### APPEAL SUMMARY

<b>Appeal ID:</b> 14737	<b>Project Address:</b> 2014 NE Multnomah St
<b>Hearing Date:</b> 3/8/17	<b>Appellant Name:</b> Martha Williams, PE
<b>Case No.:</b> P-004	<b>Appellant Phone:</b> 5039466690
<b>Appeal Type:</b> Plumbing	<b>Plans Examiner/Inspector:</b> Chuck Luttmann
<b>Project Type:</b> lur	<b>Stories:</b> 8 <b>Occupancy:</b> R-2 <b>Construction Type:</b> 1-B
<b>Building/Business Name:</b> Sullivan's Gulch	<b>Fire Sprinklers:</b> Yes - Through Out
<b>Appeal Involves:</b> Erection of a new structure, Reconsideration of appeal	<b>LUR or Permit Application No.:</b> 15-215564-CO
<b>Plan Submitted Option:</b> pdf [File 1]	<b>Proposed use:</b> Mixed Use

### **Drywell System located beneath the building: Granted as proposed**

**Re:** Drywell Infiltration Design  
Sullivan's Gulch Apartments – Parcel 1  
SE 21st Avenue and SE Multnomah Street  
Portland, Oregon

## DRYWELL LOCATION EXHIBIT SULLIVAN'S GULCH CONDOMINIUMS

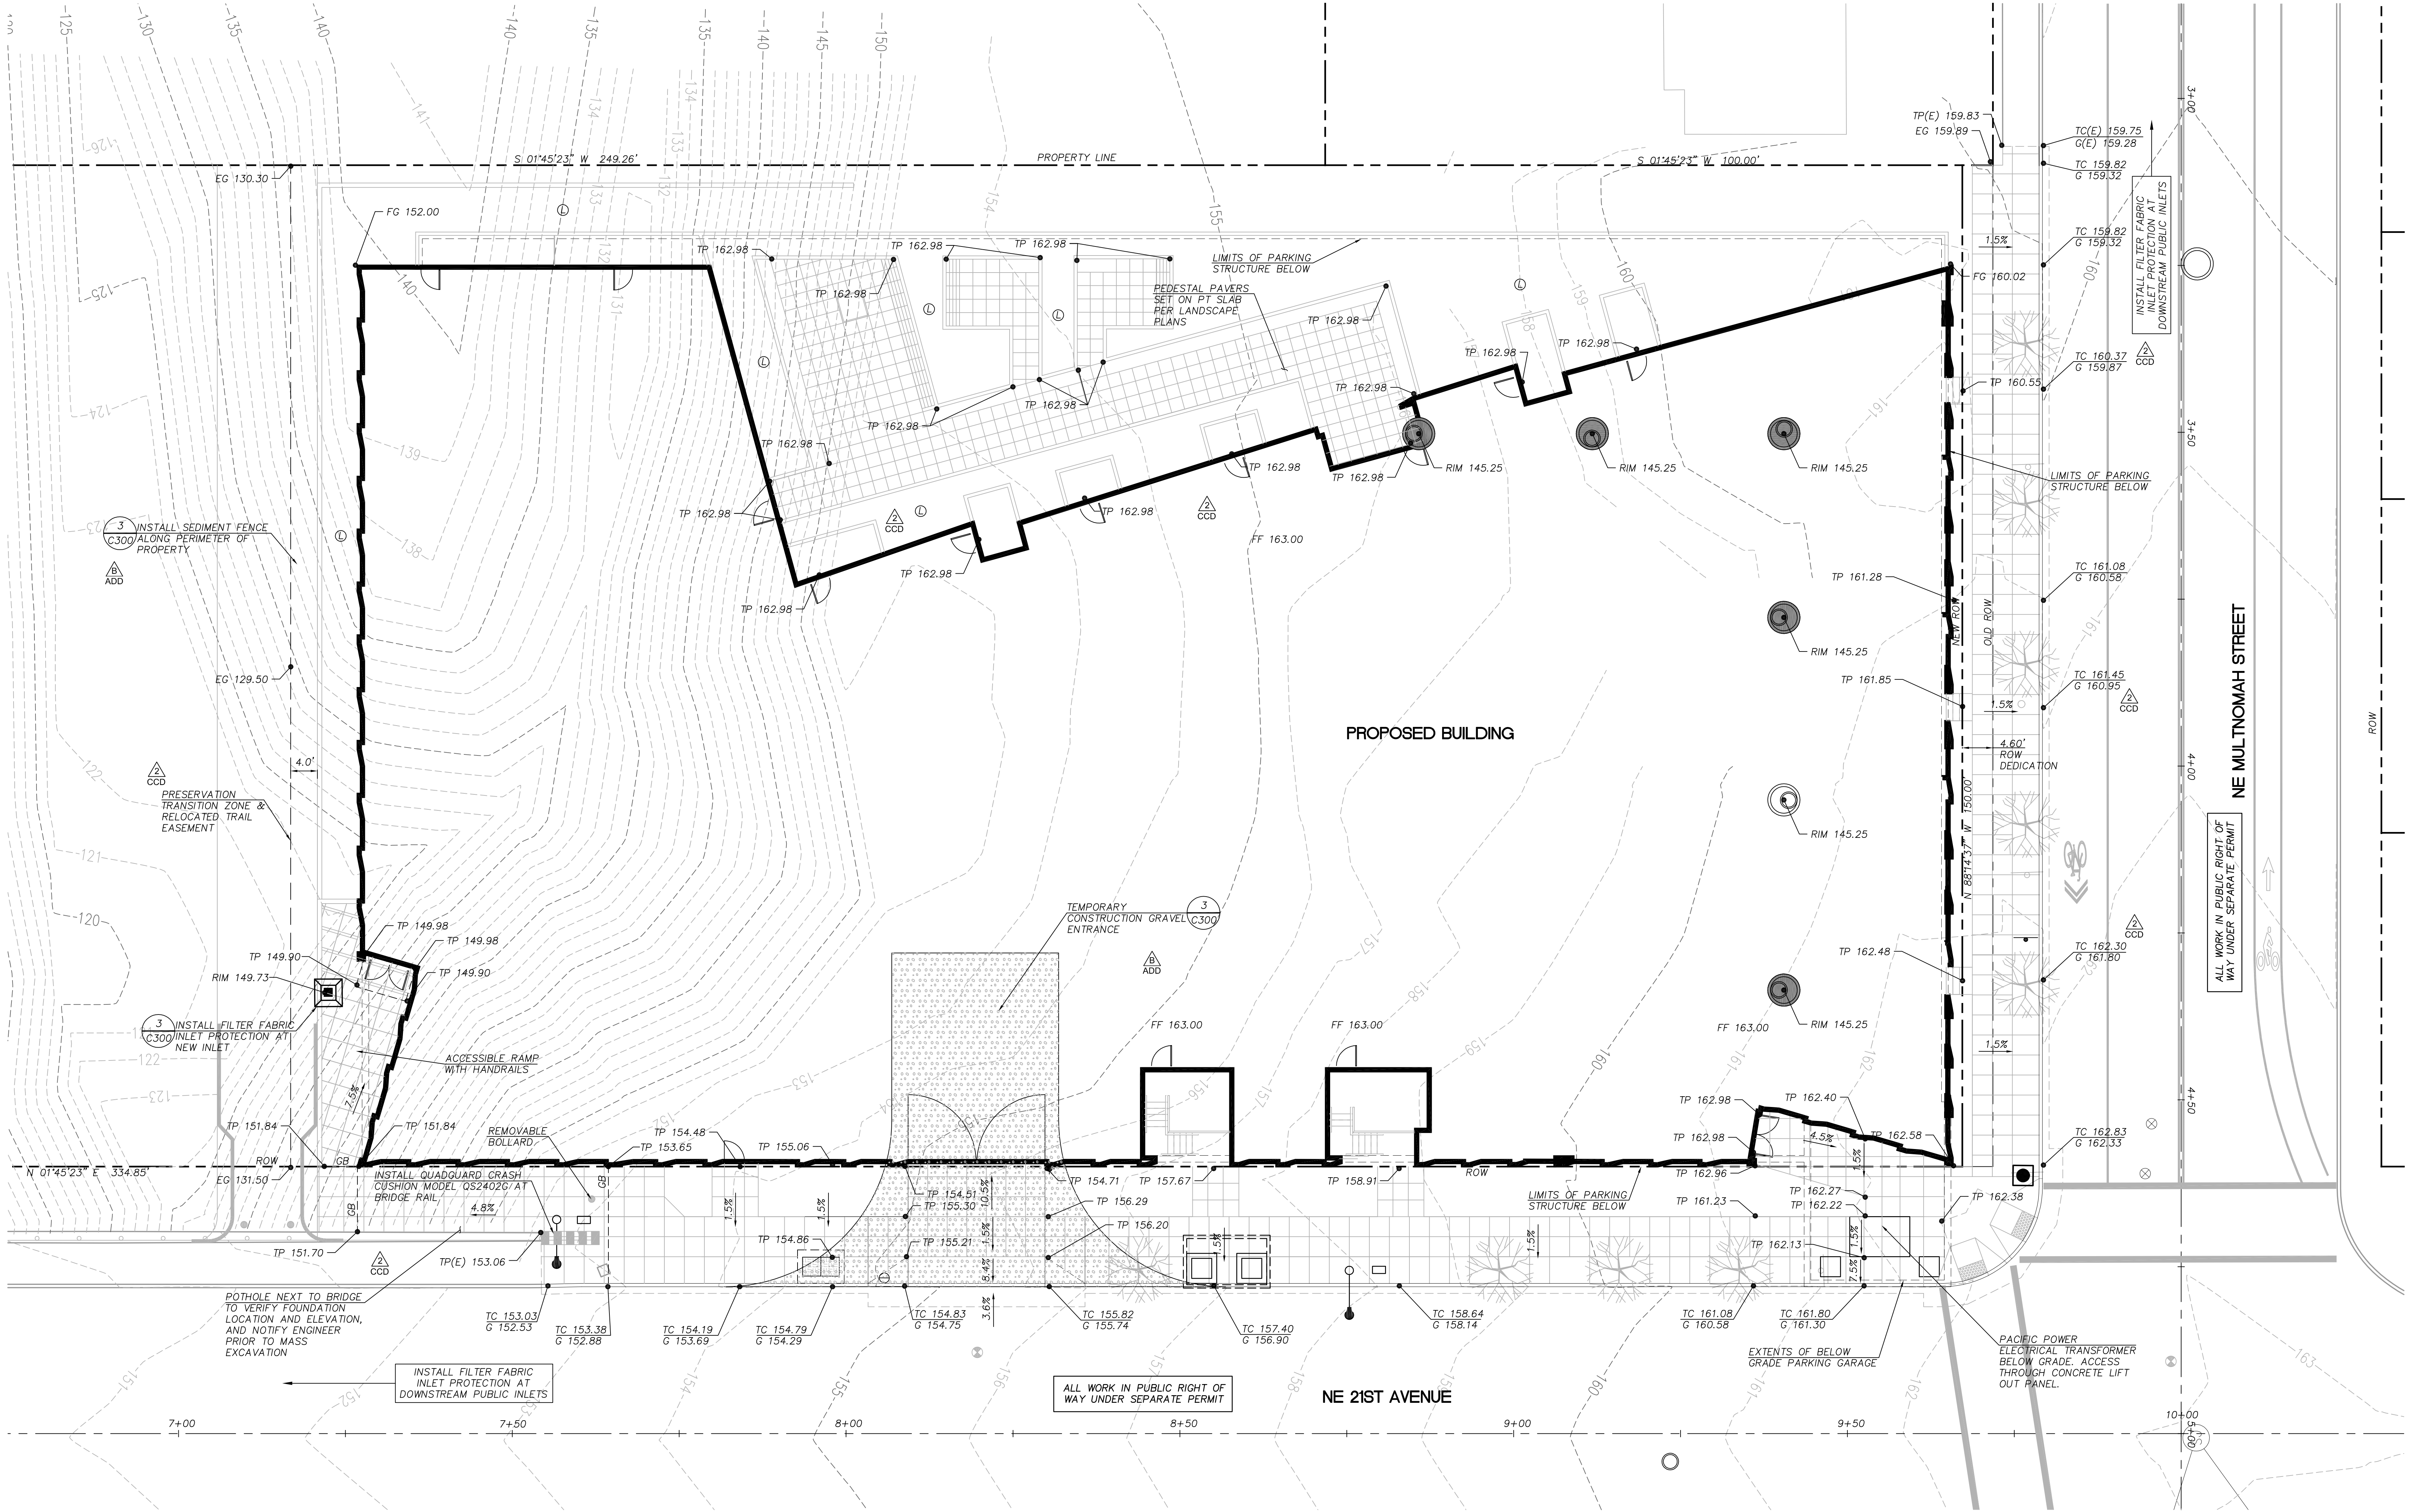
A drywell system located under the structure has been taken into account by the Geotechnical engineer, structural engineer and rammed aggregate pier designer per attached documents. Drywells will be setback a minimum of 5 feet horizontally from all footings and located on the north side of the property. Additionally, the drywells will be deep and will be discharging stormwater below a survey elevation of 120 ft (NAVD 88) which is 18.6-28.6 feet below the bottom of the footings, as recommended by the geotechnical engineer, see attached memorandum. The perforated sections of the drywell will begin approximately 44.0' below the street elevation of NE Multnomah Street.

APPEAL ITEM 1

# C300

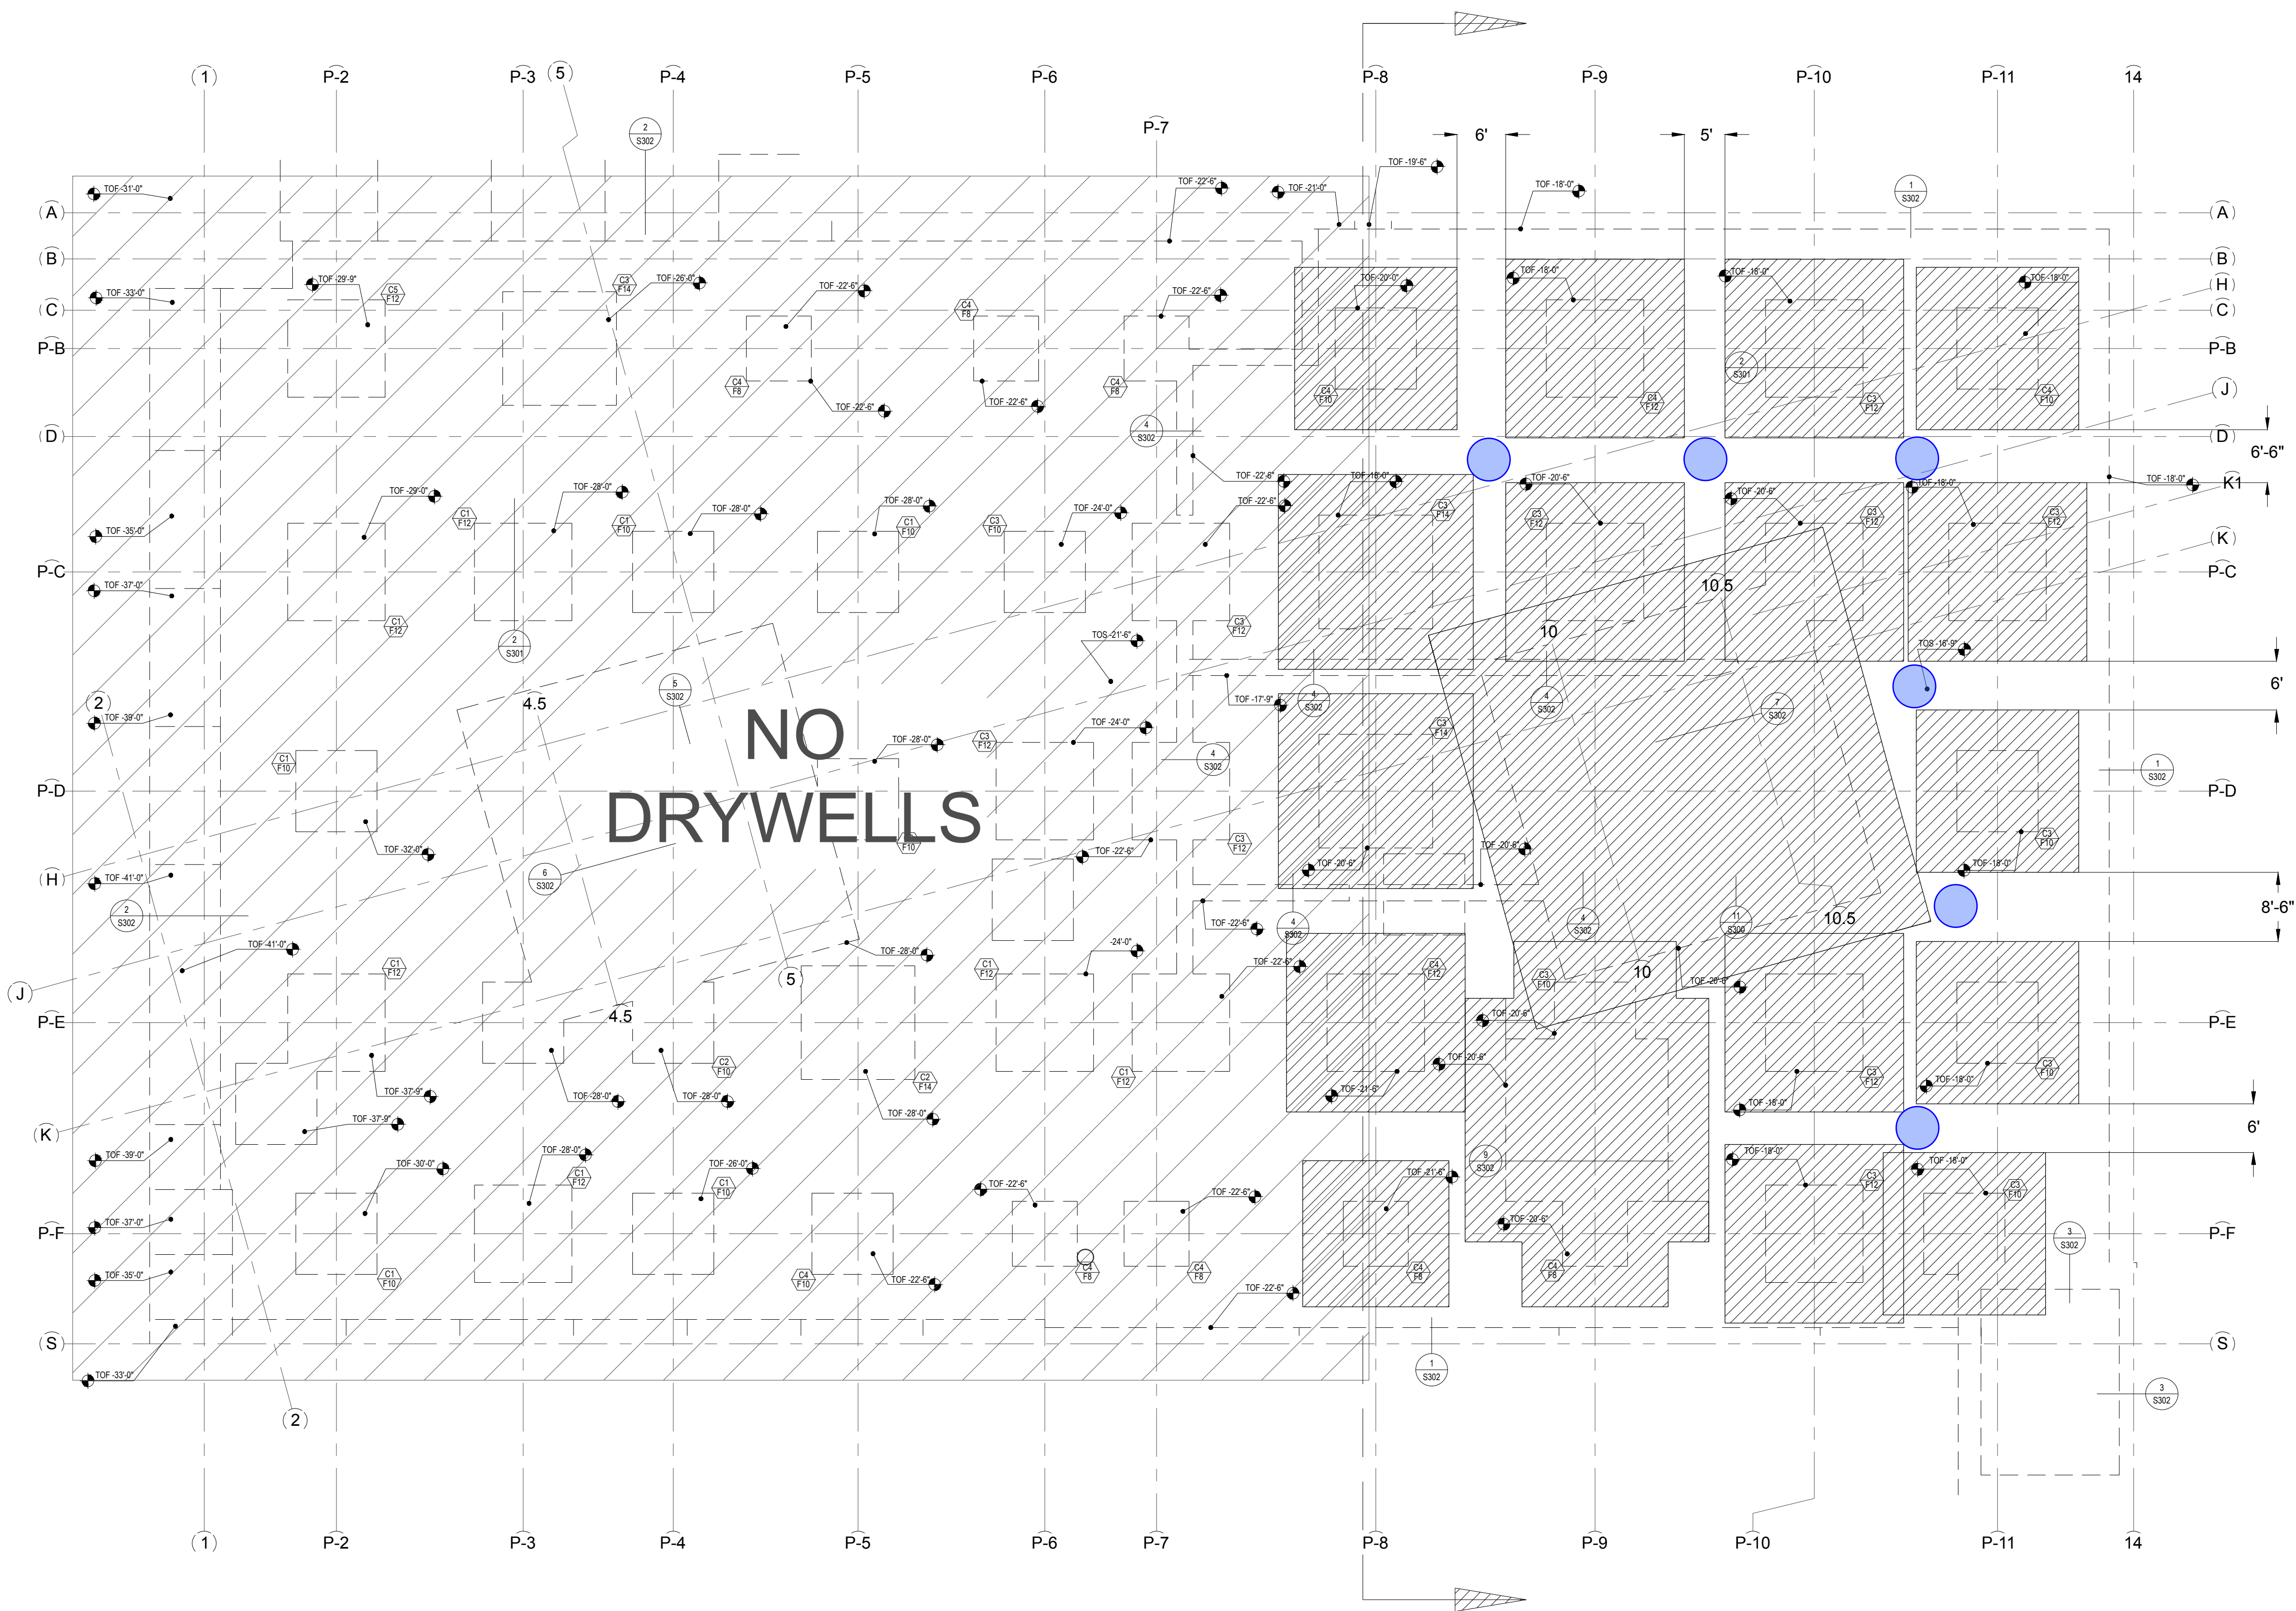
- SHEET NOTES**
- ALL DOMESTIC WATER AND FIRE PROTECTION WORK IN THE PUBLIC RIGHT OF WAY BY PORTLAND WATER BUREAU AT OWNER'S EXPENSE. CONTRACTOR TO COORDINATE WORK WITH PORTLAND WATER BUREAU.
  - ROUTE ALL STORM DRAINS AND FOUNDATION DRAIN PIPING TO DRYWELL SYSTEM.
  - INSTALL DRYWELL #1 AND TEST PER DETAIL 1/C300 PRIOR TO INSTALLING ADDITIONAL DRYWELLS.

1. DRYWELL SYSTEM SHALL HAVE THE CAPACITY TO DISPOSE OF STORMWATER AT THE COMBINED RATE OF 395 GPM.
2. SHOULD DRYWELL(S) FAIL, TO TEST AT THE MINIMUM DESIGN RATE ADDITIONAL DRYWELLS MAY BE CONSTRUCTED, AS APPROVED, IN ORDER TO ACHIEVE THE REQUIRED MINIMUM DISPOSAL RATE. ALTERNATIVE LOCATIONS AND/OR ADDITIONAL DRYWELLS IN PIPED SYSTEMS MUST BE PRE-APPROVED AND IDENTIFIED ON THE CONSTRUCTION DRAWINGS.
